# **Product Change Notification**

# **End of Life Notification**

PCN Number	: PCN129
Product Category	: Dip & SIP Switches
Issue Date	: 22/11/2019
Effective Date	: 21/11/2019
LTB Date	: N/A
LTD Date	: N/A
Reason For Change	: In order to constantly perform high quality level and fulfill customer's requirement, DA/DP series will be <b>EOL</b> and replaced by NDA/NDP series with new structure to also improved the manufacturing process.

# NDA Vs DA Appearance Comparison

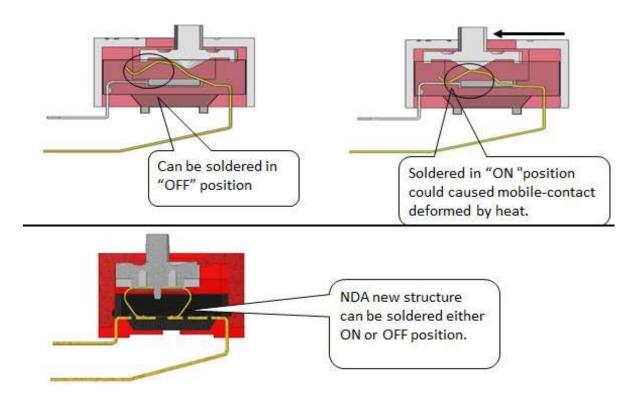
ON DIP 1 2 3 4 5 6 7 8			
TOP	Bottom	No clip mechanism gap	Contact structure
			(left to right slide)

ON DIP 1 2 3 4 5 6 7 8			
Тор	Bottom	Clip mechanism gap	Contact structure

## New Design Advantage: NDA can be solderable in "ON" or "OFF" position

NDP Vs DP Appearance Comparison

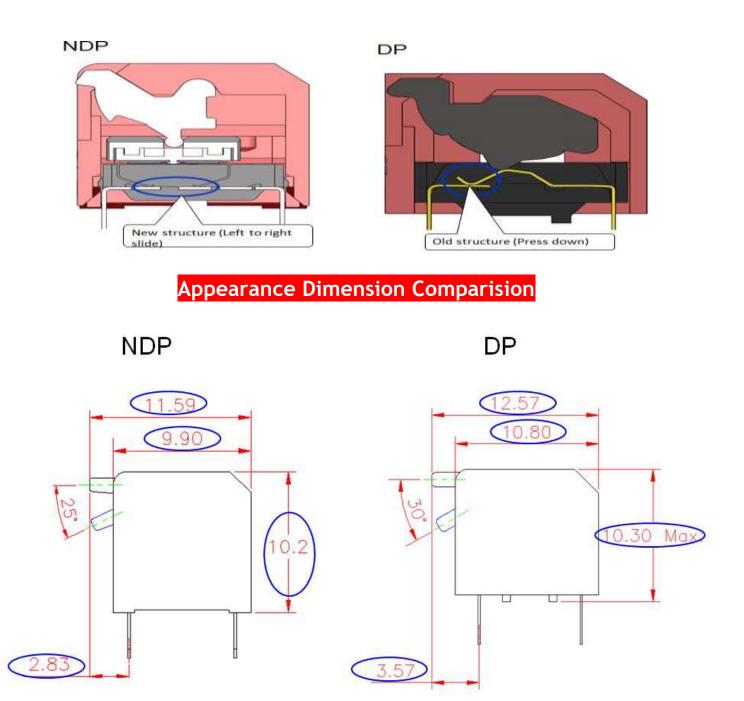
1 2 3 4 5 6 7 8 DIP ONJ	A A A A A A A A A A A A A A A A A A A		
Тор	Bottom	No clip mechanism gap	Contact structure (left to right slide)

1 2 3 4 5 6 7 8 DIP ONI			
Тор	Bottom	Clip mechanism gap	Contact structure
